Access Compliance Report

Public Rights-of-Way

(Curb Ramps)

Intersection ID: 16859	Main Street: ASHMORE_DR	Cross Street: MONROE_RD	Location: S
ADA ID: ECBFB8CC8BDD	Ramp Type: BlendTrans2	Initial Pass/Fail: Fail	Overall Compliance: No
Severity Score: 18.75			
Codes/Mitigation Info/Possible Solution		Field Measurements/Component Compliance

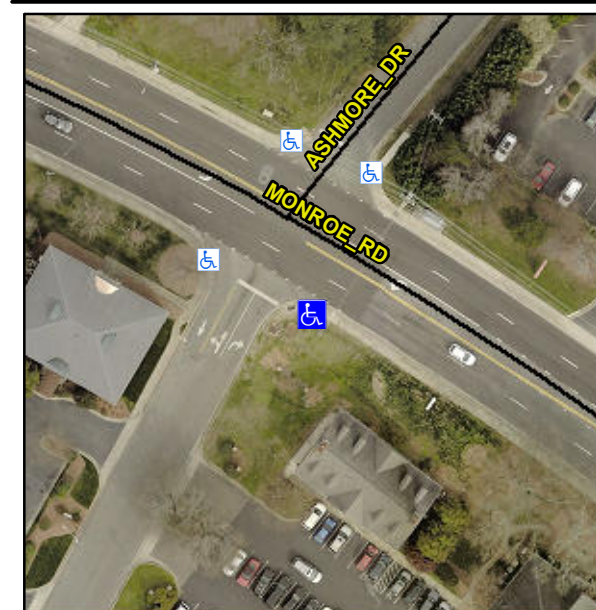
Not Found, R304.5.1, R304.5.3

Compliance	Description	Data	Compliance	Description	Data
N/A	Ramp Length (in)	59.0	Yes	BlendTrans Slope (%)	4.1
No	Ramp Width (in)	35.0	No	BlendTrans XSlope (%)	2.2
N/A	Flare Type LT	N/A	N/A	Flare Type RT	N/A
N/A	Flare Slope LT (%)	N/A	N/A	Flare Slope RT (%)	N/A
N/A	Flare Traversable LT?	N/A	N/A	Flare Traversable RT?	N/A
N/A	Landing Length (in)	N/A	N/A	DWS Provided?	N/A
N/A	Landing Width (in)	N/A	N/A	DWS Contrast?	N/A
N/A	Landing Slope (%)	N/A	N/A	DWS Length (in)	N/A
N/A	Landing X Slope (%)	N/A	N/A	DWS Full Width?	N/A
N/A	Landing Curb? (Y/N)	N/A	N/A	DWS Offset (in)	N/A
N/A	Shared Landing?	N/A			
N/A	Gutter Ponding?	N/A	N/A	Gutter Slope (%)	N/A
N/A	Gutter Lip Ht (in)	N/A	N/A	Gutter X Slope (%)	N/A
N/A	Painted X Walk1?	No	N/A	Painted X Walk2?	No
	X Walk 1 Direction	To NE		X Walk 2 Direction	To NW
	X Walk 1 Width (in)	N/A		X Walk 2 Width (in)	N/A
	X Walk 1 Slope (%)	2.1		X Walk 2 Slope (%)	0.4
	X Walk 1 X Slope (%)	0.6		X Walk 2 X Slope (%)	2.1

N/A	Ramp inside XWalk1?	N/A	N/A	Ramp inside XWalk2?	N/A
	Road Slope (%)	1.4		Clear Space?	N/A
	Road X Slope (%)	1.5	N/A	Clear Space to XWalk (in)	N/A
N/A	Any Obstructions?	N/A	N/A	Storm Grate/Utility Hazard?	N/A
	Obstruction Type			Storm Grate/Utility Type	
		N/A			N/A
			Yes	Surface Condition? (G/P)	Good
			No	Curb Slope (%)	9.4

Remove & Replace Curb Ramp With Two New Directional Ramps or Equivalent.
